ORIGINATION FORM

Proposed Revisions to a Standard Plans Index
(Please provide all information — Incomplete forms will be returned)

Index Number: 521-660

Index Title: Light Pole Pedestal - Bridge

TABLE 1 - DESIGN LIMITATIONS FOR ANCHOR BOLTS (1" Dia.)

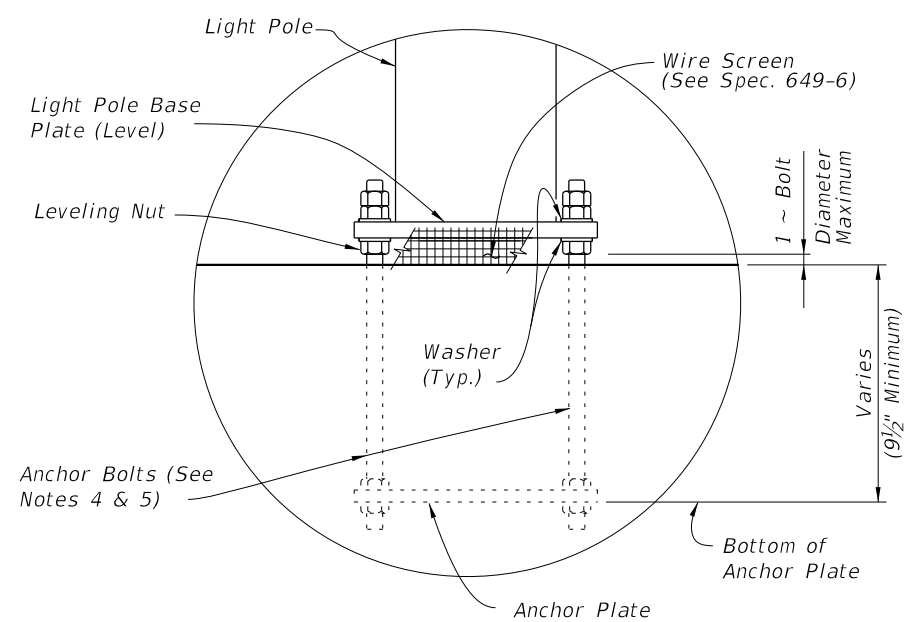
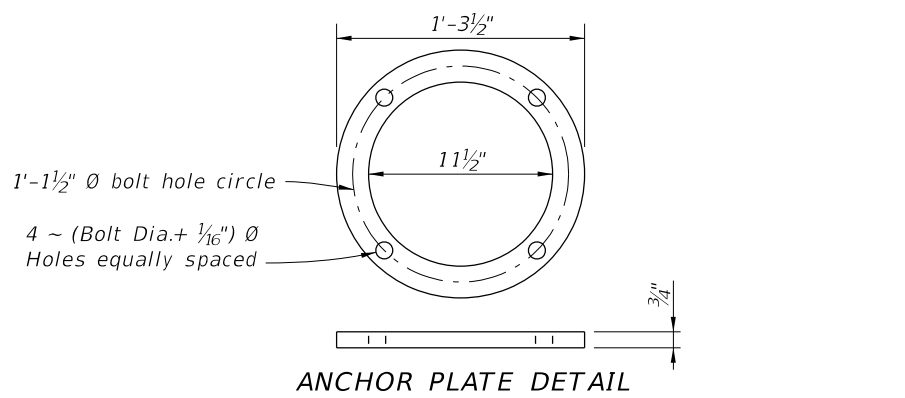
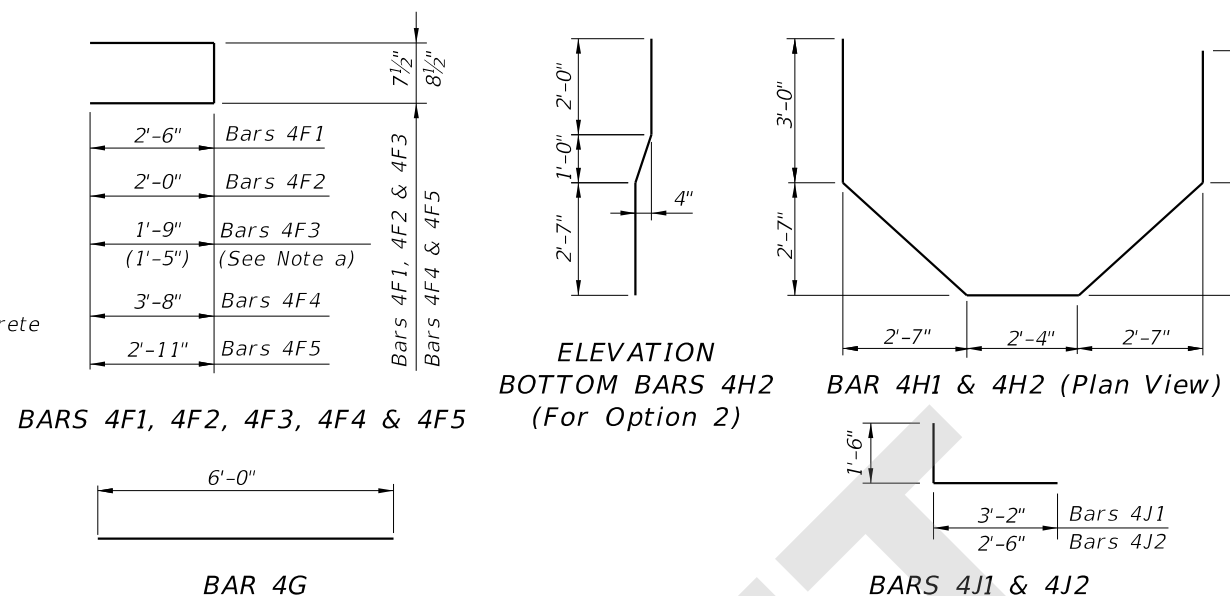
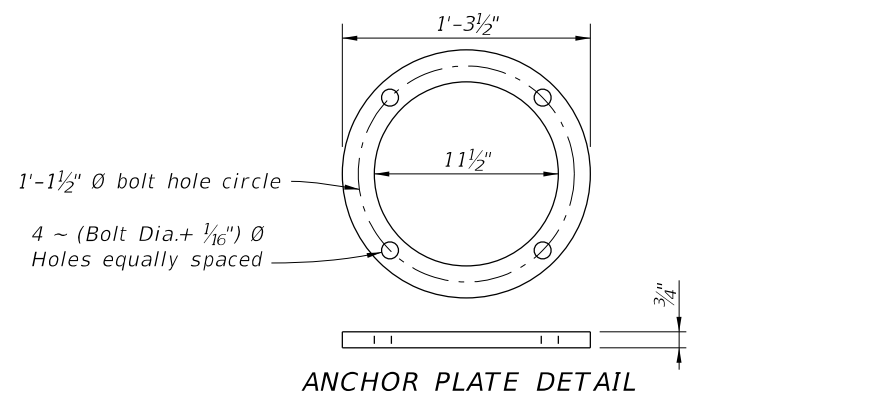
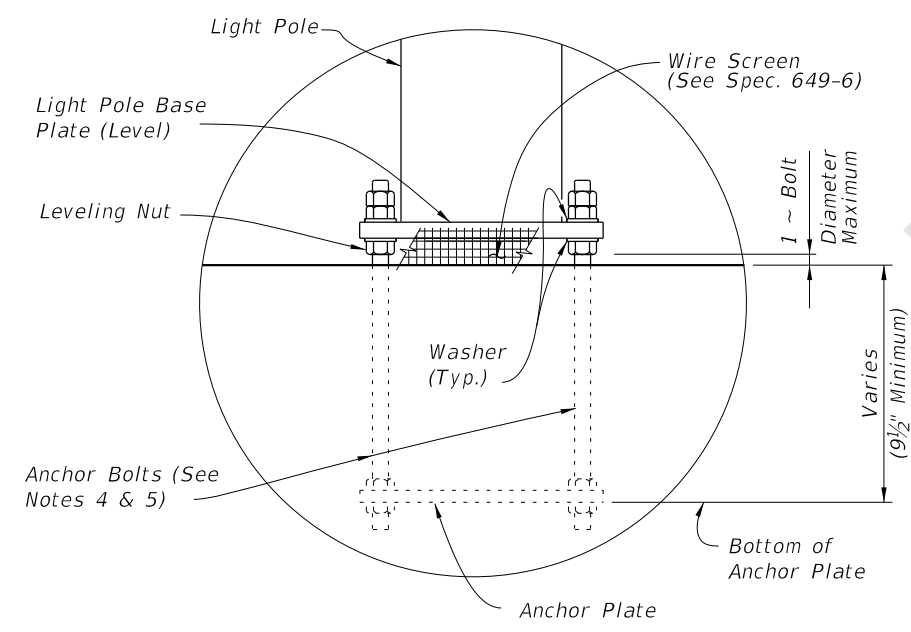
Sheet 4: Changed wind speeds in Table 1

Update to match current criteria

130
150
170
170

| WIND SPEED (MPH) | ARM LENGTH (Ft.) | BRIDGE DECK HEIGHT (Ft.)* | | |
|------------------|------------------|---------------------------|--------|--------|
| 130 | ≤ 15 | 75 | 75 | 75 |
| 150 | ≤ 15 | 75 | 75 | 75 |
| 170 | 8 & 10 | 75 | 75 | 45** |
| 170 | 12 & 15 | 75 | 75 | 25** |
